USB_DAQ_POWER

HEP, Imperial College, London		
Title: USBDAQ/WR238		Engineer:
Subtitle:		Drawn by:
v0.2f	12.12.06	Ver:
Sheet: X	of: X	Date: 21.11.06

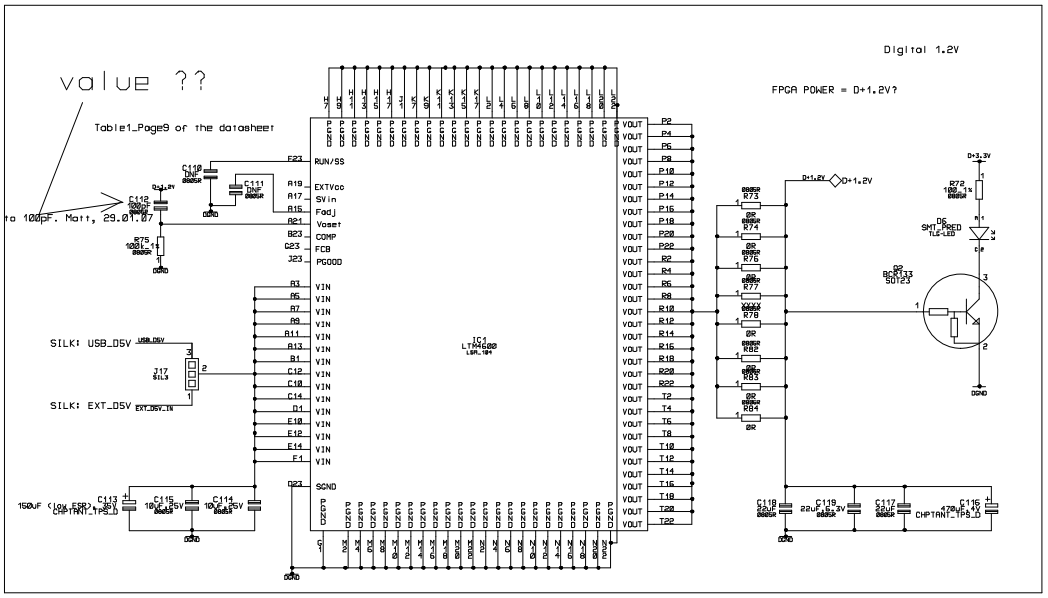
Please see layout guidlines in datasheets for both these regulators.

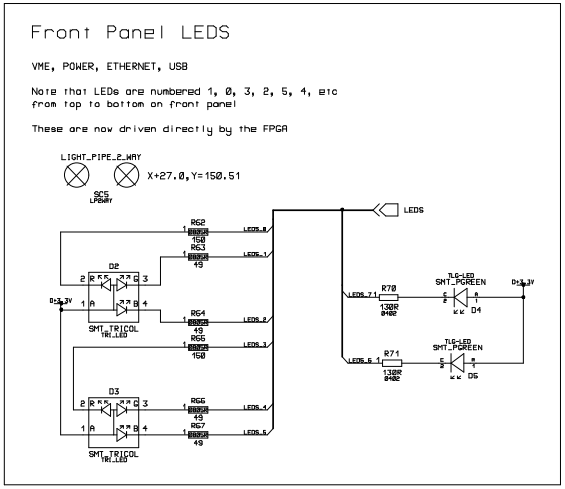
looked again at the datasheet and it is 10pF. Matt, 29.01.07

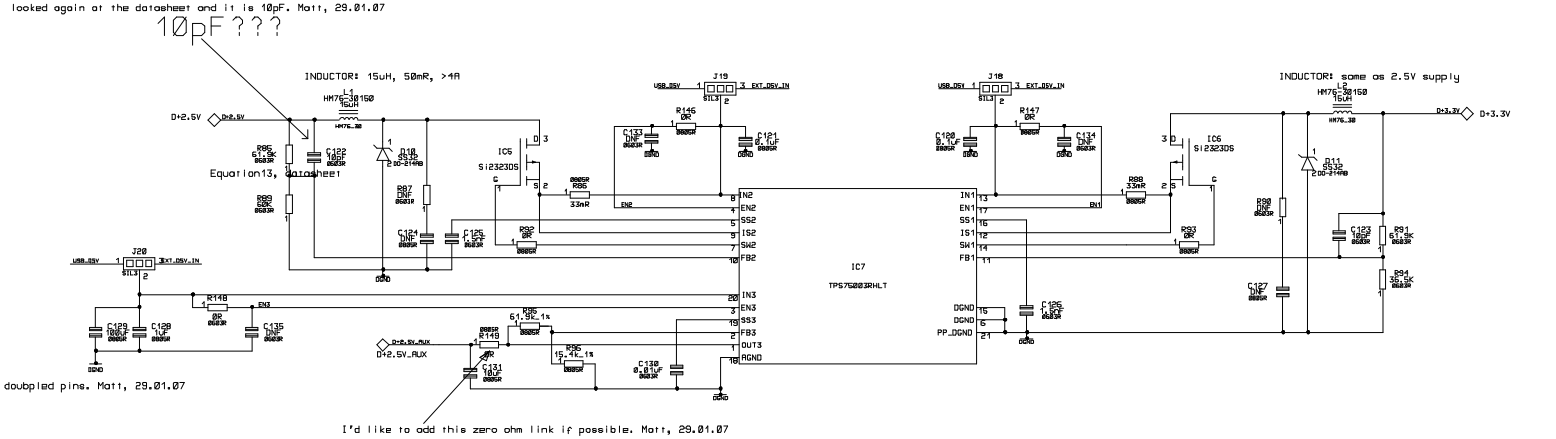
Added D+2.5V_AUX power connection here, doubpled pins. Matt, 29.01.07
